ITEM: 6.18	REPORT SUMMARY MINOR VARIANCE APPLICATION FILE NUMBER A131/24
-------------------	--

CITY WARD #:	3
APPLICANT:	Mohammadreza Rostamshirazi & Parvaneh Zamani
AGENT:	Mohammad Kandi
PROPERTY:	335 Vellore Avenue, Woodbridge
ZONING DESIGNATION:	See below.
VAUGHAN OFFICIAL PLAN (2010) DESIGNATION:	Vaughan Official Plan 2010 ('VOP 2010'): "Low-Rise Residential"
RELATED DEVELOPMENT APPLICATIONS:	None
PURPOSE OF APPLICATION:	Relief from the Zoning By-law is being requested to permit stair access to proposed side entrance (to support secondary suite) and to permit the existing shed located in the rear yard.

PROJECT:
PROPOSED SECONDARY SUITE
335 VELLORE AVENUE,
VAUGHAN, ONTARIO

TITLE:
SITE PLAN

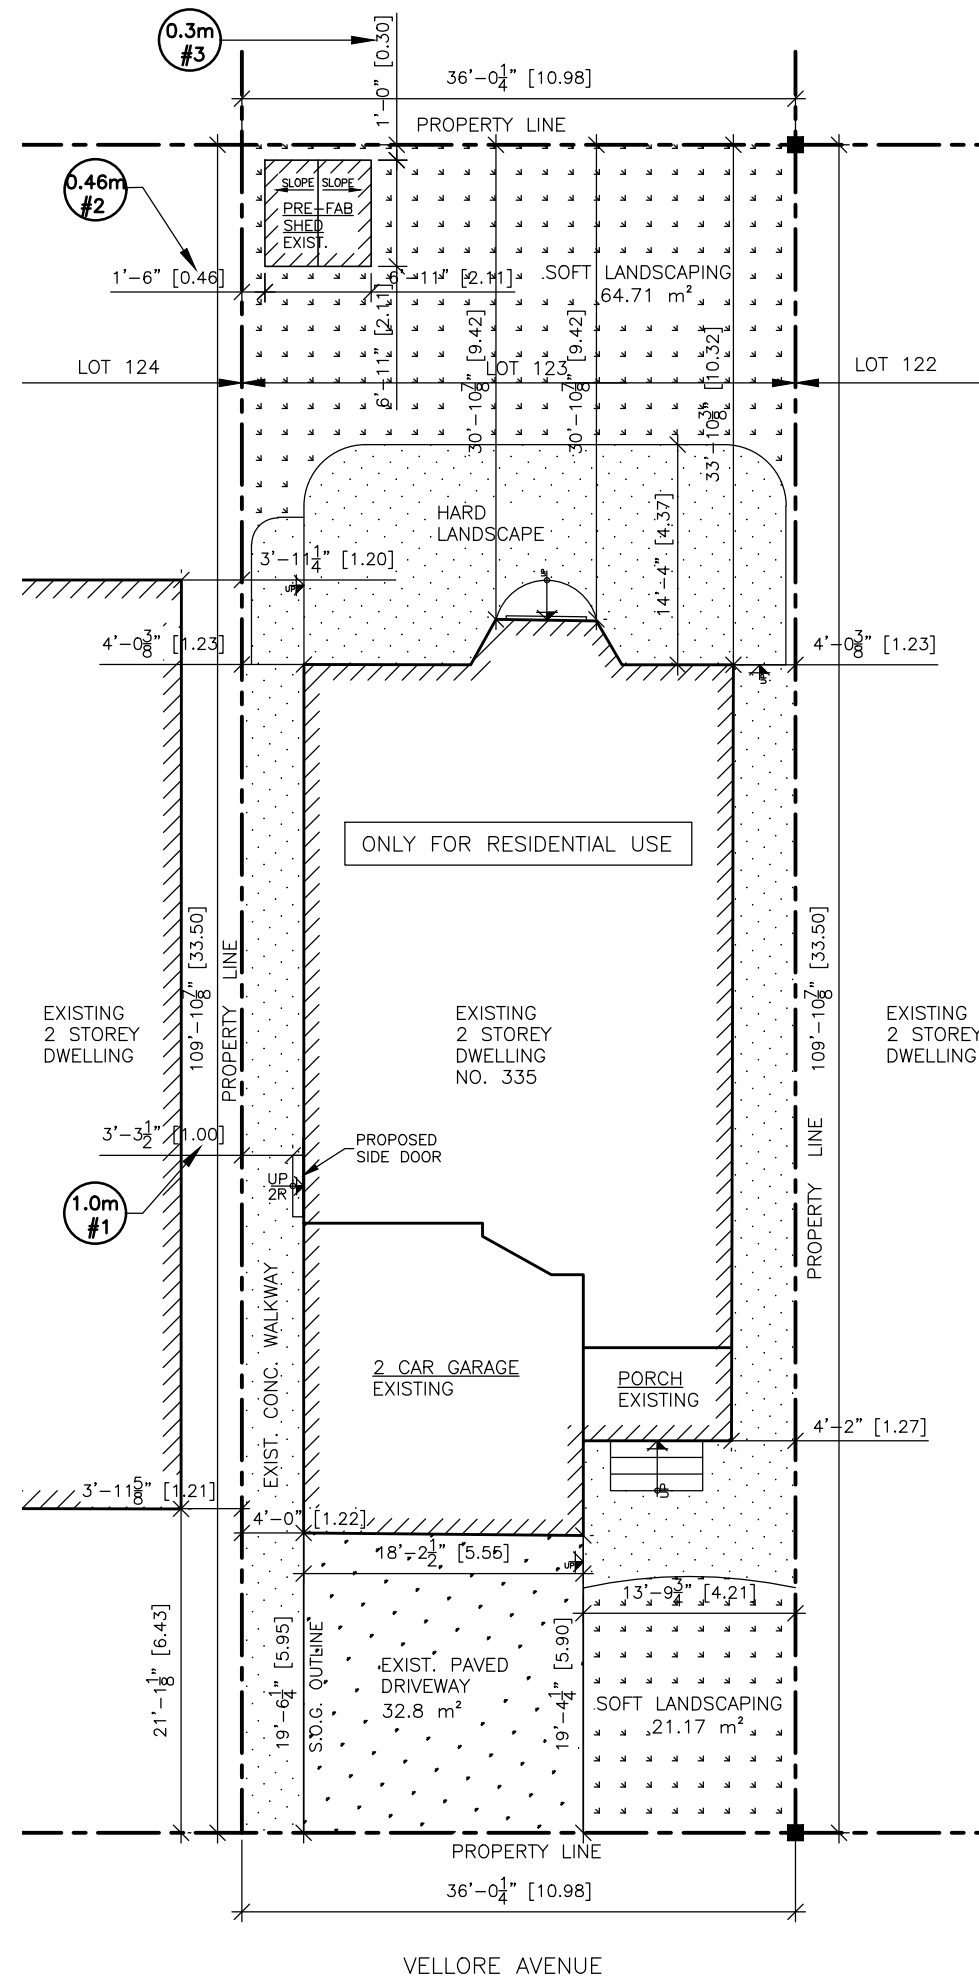
The Development Planning Department has no objection to Variance 1 for the proposed 0.2 m access step encroachment into the required 1.2 m unobstructed hard landscaped surface walkway. The dwelling is set back 1.22 m from the north interior side lot line. The secondary suite access pathway is proposed to occupy all of this space. The intent of the provision is to maintain access of sufficient width to the secondary suite to accommodate a variety of purposes. As the reduction is sought to accommodate a single step to gain access to the secondary suite entrance, and the step's height is very modest, the intent of the access provision is maintained. Therefore, the reduction of 0.2 m to the required walkway width is minor in nature and remains adequate to facilitate access to the secondary suite entrance at the side of the dwelling.

The Development Planning Department has no objection to Variances 2 and 3 for the existing accessory structure (shed) located 0.46 m from the northerly interior side lot line (Variance 1) and 0.30m from the rear lot line (Variance 2). The shed is located in the north-east corner of the rear yard and is enclosed on all four sides. The shed is relatively modest in size and complies with the maximum height requirements and maximum lot coverage requirements of the Zoning By-law for accessory buildings and structures. As a modest storage structure, the shed is not anticipated to have adverse use (privacy) or massing impacts on the neighbouring properties to the north (339 Vellore Avenue) and to the east (18 Mazzone Drive). The 0.46 m minimum interior side yard setback and 0.30m rear yard setback provides sufficient space for safe maintenance and access purposes. Development Engineering staff have also reviewed the application and do not have any concerns regarding drainage in the rear yard.
